**DEPARTMENT OF TRANSPORTATION****Federal Aviation Administration****14 CFR Part 39**

[Docket No. FAA-2011-0994; Directorate Identifier 2010-NM-143-AD]

**Airworthiness Directives; Bombardier, Inc. Model CL-600-2C10 (Regional Jet Series 700, 701, & 702), CL-600-2D15 (Regional Jet Series 705), and CL-600-2D24 (Regional Jet Series 900) Airplanes****AGENCY:** Federal Aviation Administration (FAA), DOT.**ACTION:** Notice of proposed rulemaking (NPRM).

**Figure 1**  
LH side shown  
RH side opposite

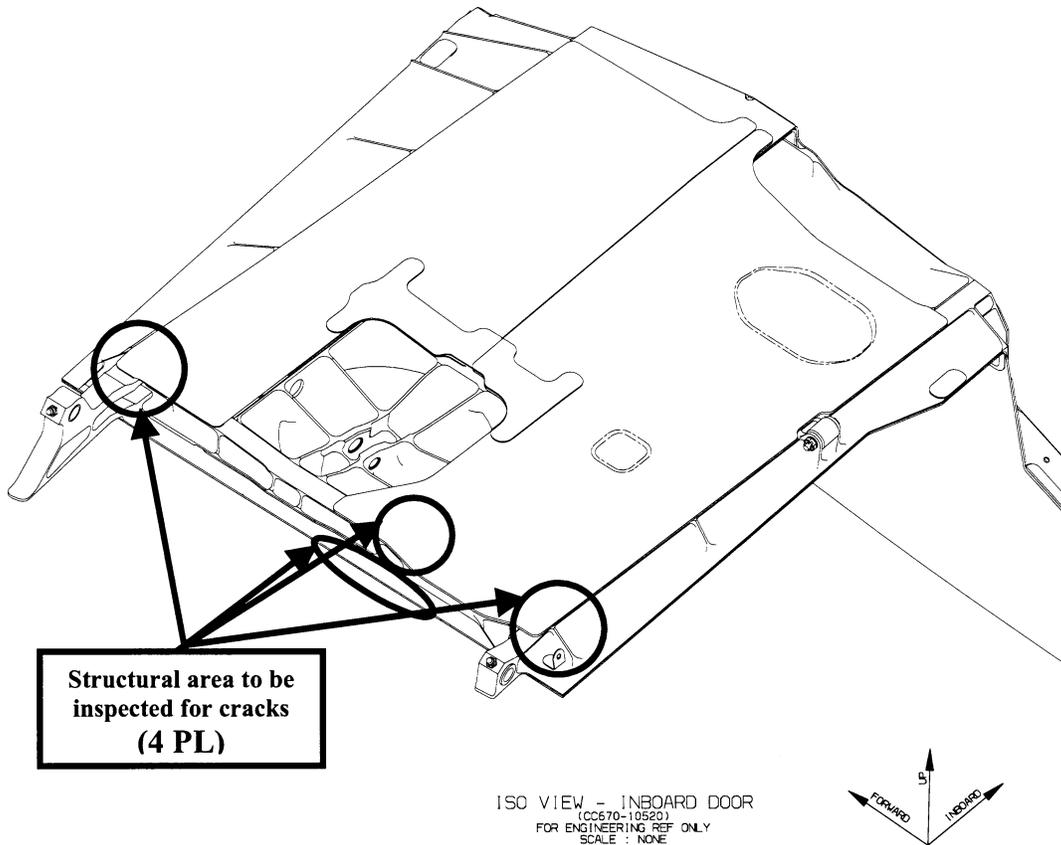
(h) For Model CL-600-2C10 (Regional Jet series 700 & 701) series airplanes, S/Ns 10003 through 10230 inclusive; and Model CL-600-2D24 (Regional Jet series 900) series airplanes, S/Ns 15002 through 15053 inclusive, 15055 and 15056: At the applicable time specified in paragraph (g) of this AD, perform detailed inspections of the lower panel, part number (P/N) CC670-10520, of the left- and right-hand MLG doors for the conditions and in the areas specified in paragraphs (h)(1), (h)(2), (h)(3), and (h)(4) of this AD; and Figures 1, 2, and 3 of this AD.

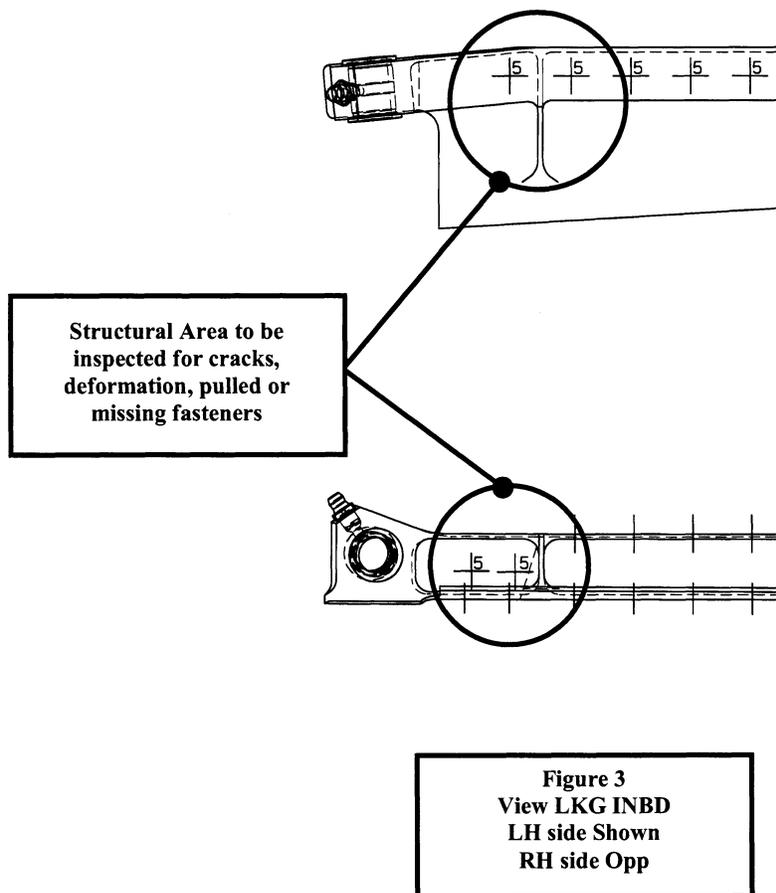
(1) Inspect the cross member, P/N CC670-10572, of the MLG door lower panel for cracking or deformation, in accordance with Figure 2 of this AD.

(2) Inspect the inner skin, P/N CC670-10577, of the MLG door lower panel at the cross member (P/N CC670-10572) for cracking or deformation, or pulled or missing fasteners, in accordance with Figure 2 of this AD.

(3) Inspect the outer skin, P/N CC670-10574, of the MLG door lower panel at the cross member (P/N CC670-10572) for cracking or deformation, or pulled or missing fasteners, in accordance with Figure 2 of this AD.

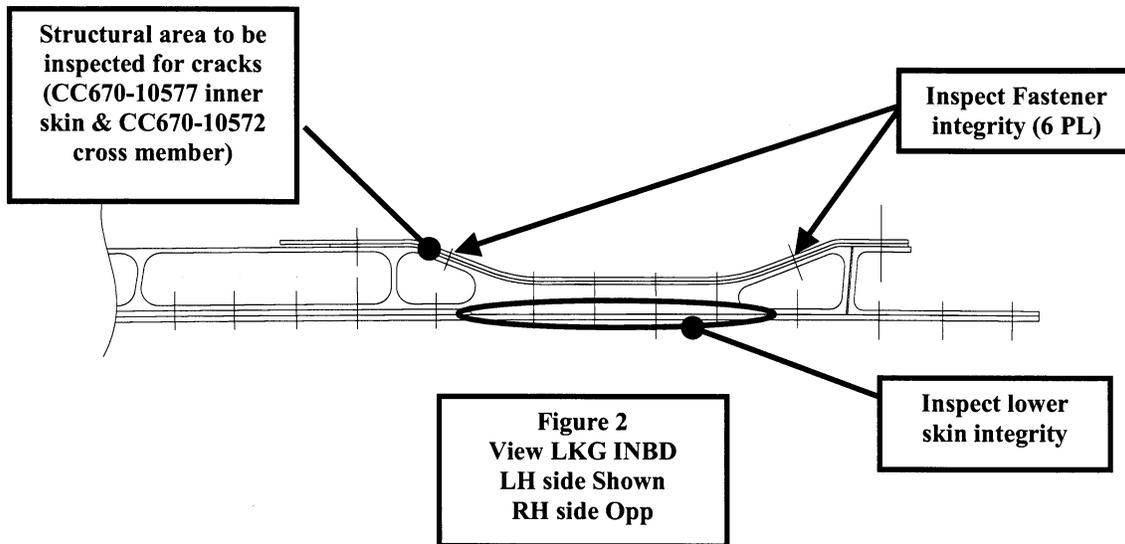
(4) Inspect the forward member, P/N CC670-10570, and aft member, P/N CC670-10571, of the MLG door lower panel for cracking or deformation, or pulled or missing fasteners, in accordance with Figure 3 of this AD. Figures 1 through 3 of this AD follow.
